Microcomputer Technical Information

IE-703107-MC-EM1 In-Circuit Emulator Option Board for V850E/MA1, V850E/MA2 Usage Restrictions		Document No.	ZBG-CD-04-0005	1/2
		Date issued	May 17, 2004	
		Issued by	Development Tool Group Multipurpose Microcomputer Systems Division 3rd Systems Operations Unit NEC Electronics Corporation	
Related documents	IE-703107-MC-EM1 User's Manual: U14481EJ2V0UM00	Notification classification	√	Usage restriction
				Upgrade
				Document modification
				Other notification

- No.14 Bug in _HLDK signal output

No.13 Restriction on A/D converter

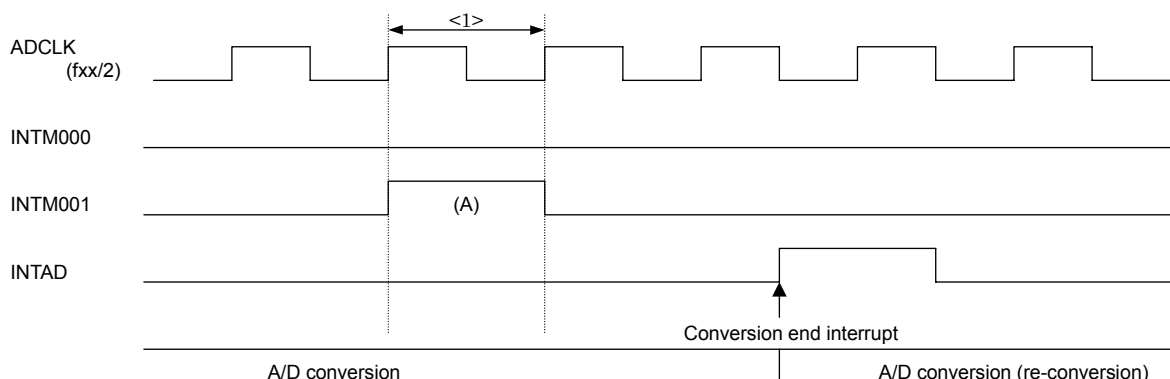
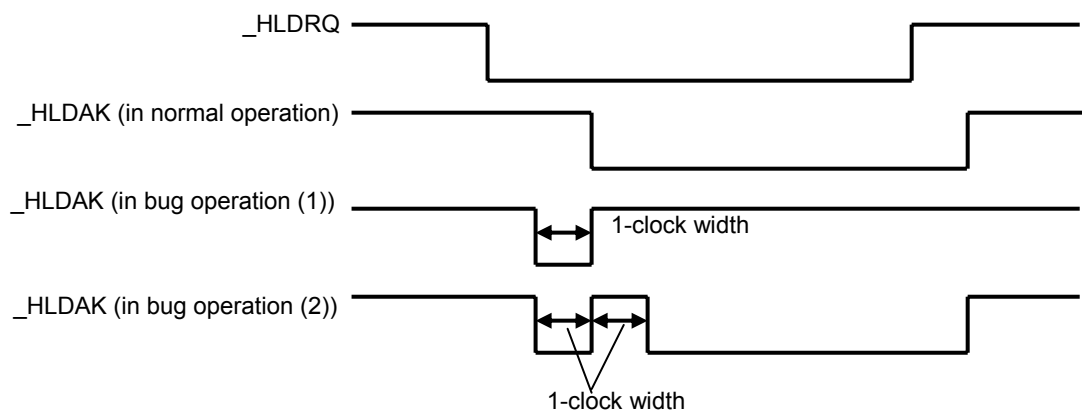
This restriction occurs when the timer 1 trigger mode or external trigger mode of the A/D converter is used (this bug does not occur when the A/D trigger mode or timer 4 trigger mode is used).

Originally, only INTM000 can be the trigger to start the A/D converter in the timer 1 trigger mode, and ADTRG pin input in the external trigger mode, therefore the interrupt sources listed below should be ignored. However, if one of the interrupt sources listed below occurs immediately before the end of A/D conversion (<1> in the figure below; 2 internal system clocks), it is mistakenly judged as the A/D conversion start trigger. As a result, A/D conversion is started again after the A/D conversion end interrupt (INTAD) is issued. The first A/D conversion ends correctly and the result is stored in the ADCRn register (this value can be read during the second conversion).

Note The external interrupt signal that functions alternately as the external capture trigger input of timer C (channels 0 and 1) can also be a trigger for re-conversion. In the case of an external interrupt input, this bug occurs when a valid edge is input before the timing of (A) in the figure below by the noise eliminator (analog delay (60 to 220 ns)).

Since the conversion result is correct even when this bug occurs, the affect of this bug is small when obtaining the latest conversion value. If the re-conversion causes any problems, start A/D conversion in the A/D trigger mode by setting the ADCE bit of the ADM0 register to 1 in the interrupt service routine of the timer match interrupt.

◆ JP4 position

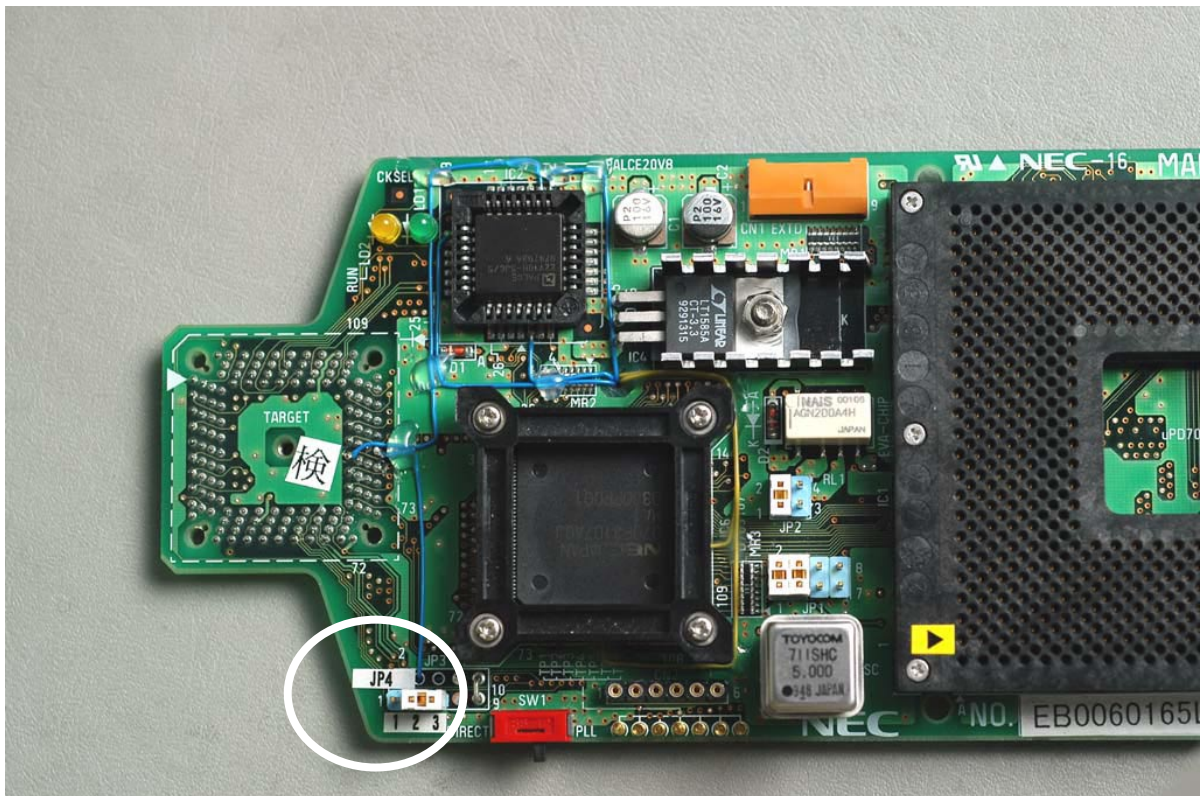
The _HLDAK signal output from the emulator in response to the _HLDRQ signal from the target system may be illegal (there are two cases).

This bug occurs only when output of the _HLDAK signal and refresh conflict.

The function of JP4 that is provided in control code E (V1.33) is described below.

2-3 shorted: Setting to prevent _HLDAK illegal output

1-2 shorted: Setting functions other than above (factory setting)

(1) Set 2-3 shorted only for the following system.

- A system in which DRAM or SDRAM is connected to the external bus and the bus hold function is used.

(2) Set 1-2 shorted for systems other than above.

- A system in which DRAM or SDRAM is connected to the external bus and the bus hold function is not used.
- A system in which a device other than DRAM or SDRAM is connected to the external bus.
- A system which is used by the port function.
